Well Name: EW MUDGE COAL 16	Well Location: T25N / R11W / SEC 16 / NWSW / 36.3987 / -108.01444	County or Parish/State: SAN JUAN / NM
Well Number: 1	Type of Well: OTHER	Allottee or Tribe Name:
Lease Number: NMNM036253	Unit or CA Name:	Unit or CA Number:
US Well Number: 3004531967	Well Status: Gas Well Shut In	Operator: DJR OPERATING LLC

Type of Submission: Notice of Intent	Type of Action: Plug and Abandonment
Date Sundry Submitted: 02/22/2022	Time Sundry Submitted: 11:48
Date proposed operation will begin: 02/22/2022

Plug and Abandonment Procedure
for
DJR Operating, LLC
EW Mudge Coal 16 1
API # 30-045-31967
NW/SW, Unit L, Sec. 16, T25N, R11W
San Juan County, NM

AFMSS 2 Sundry ID 2658318

DJR Operating, LLC
Proposed Wellbore Diagram

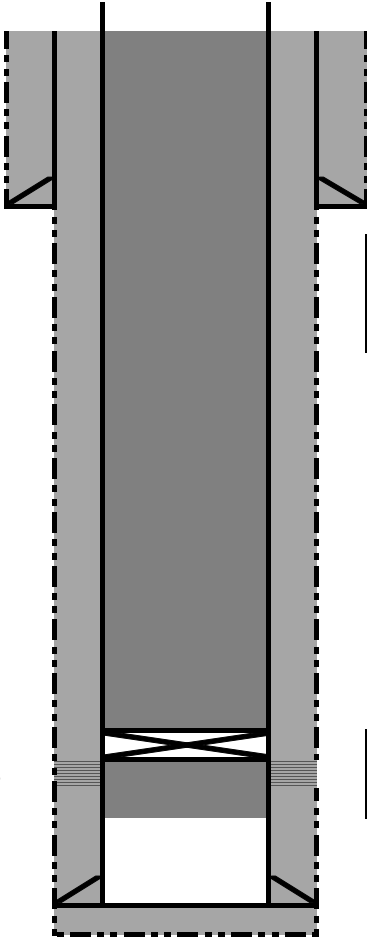
You are also required to place cement excesses per 4.2 and 4.4 of the attached General Requirements.
